Re: Response to Planning Comments hearing 5.16.18

Dicome planning comment response to hearing 5.16.18

PLAT OF  
**LOT 1 THRU 6**  
**SIGNAL VILLAGE**  
 WITHIN THE  
**ELENA GRANT**  
 PROJECTED SECTION 17  
 TOWNSHIP 11 NORTH, RANGE 4 EAST, N.M.P.M.  
 CITY OF ALBUQUERQUE  
 BERNALILLO COUNTY, NEW MEXICO  
 APRIL, 2018

EXHIBIT "A"

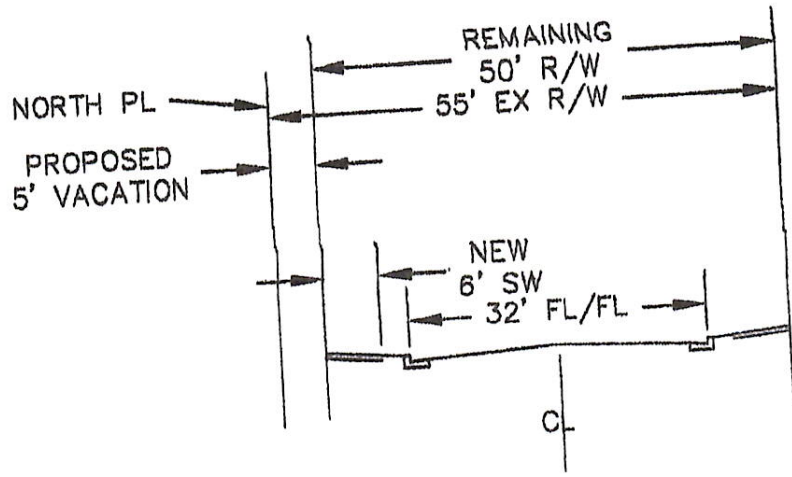
6. I've labeled Waiver/deferral of S/W as "Exhibit A" (see attached).
7. I've labeled Signal Ave. Proposed Cross-Section as "Exhibit B" (see attached). Previously, I used this exhibit for Signal Pointe Subdivision. Is this acceptable to you and the Traffic Engineer?

VENTURA AVENUE, NE  
PROPOSED CROSS-SECTION

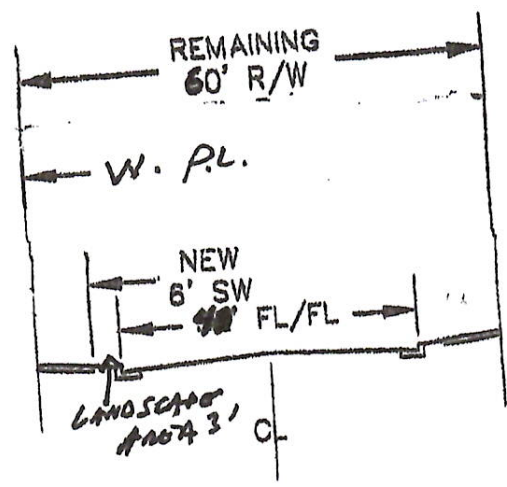
9. I've labeled Ventura Proposed Cross-Section as "Exhibit D" (see attached). Is this acceptable to you and the Traffic Engineer?
10. I've labeled Site Sketch as "Exhibit E" (see attached).

**PLAT OF  
LOT 1 THRU 6  
SIGNAL VILLAGE  
WITHIN THE  
ELENA GRANT  
PROJECTED SECTION 17  
TOWNSHIP 11 NORTH, RANGE 4 EAST, N.M.P.M.  
CITY OF ALBUQUERQUE  
BERNALILLO COUNTY, NEW MEXICO  
APRIL 2018**

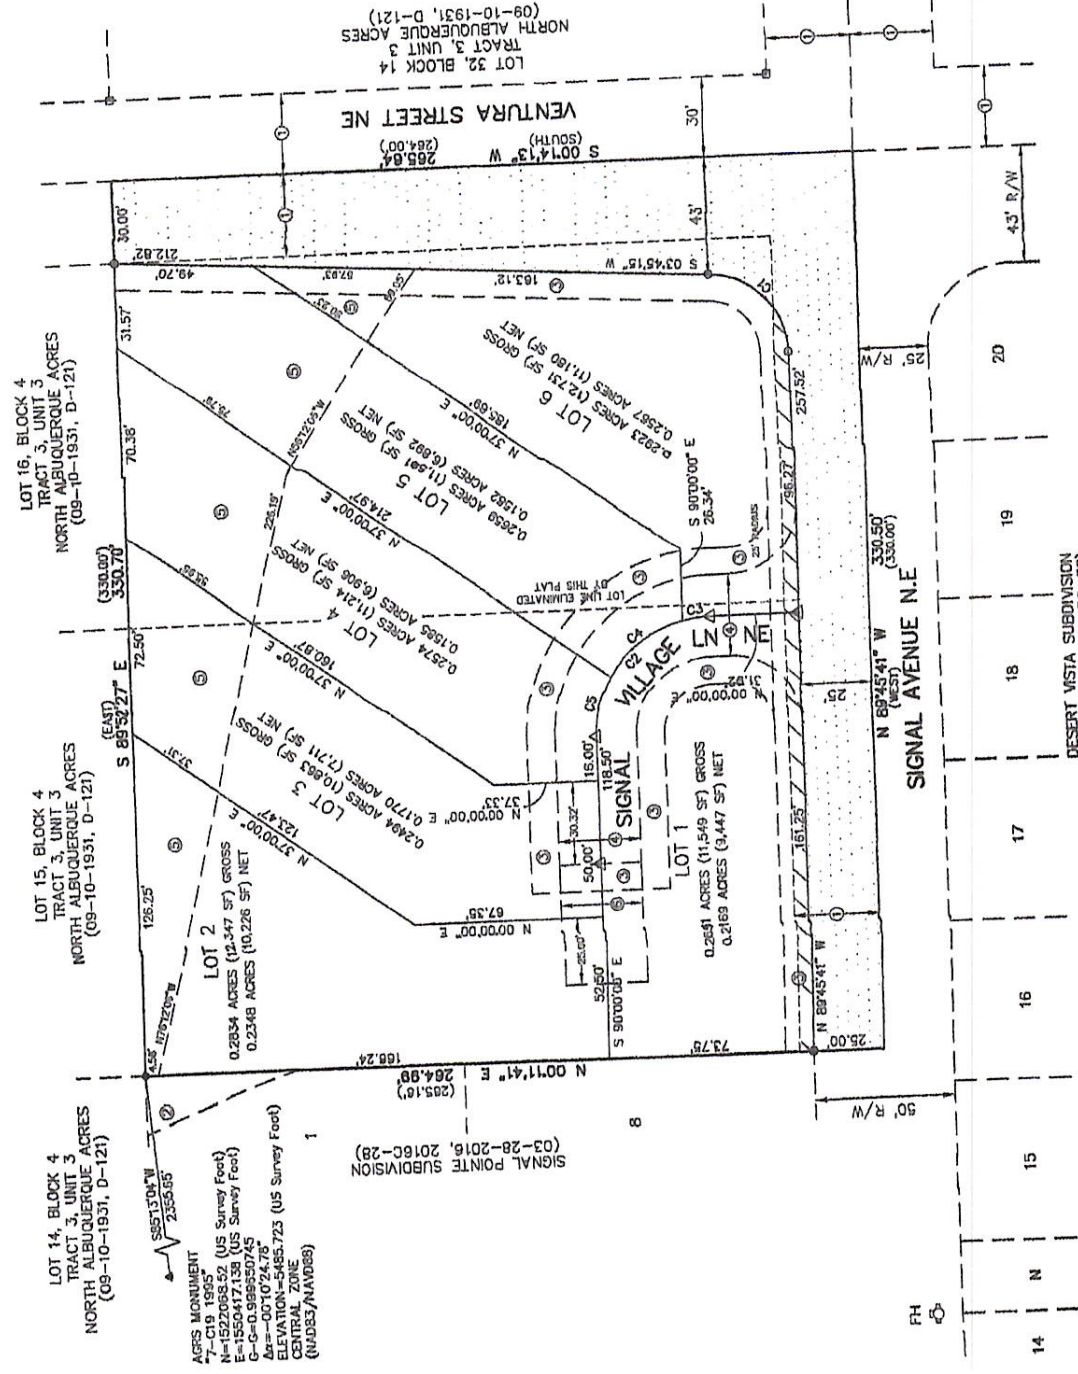
Per your request, I've attached a copy of the Fire Marshall's approval of Signal Village and a copy of the plat showing the Fire Hydrant on Signal allowing us to reduce the pipe in Signal Village Ln to a 4" line per your suggestion. In addition, I've attached a revised copy of the infrastructure list for your review. Please let me know if there is any other information you require at your earliest convenience so I can chase it down prior to the June 13, 2018 hearing.
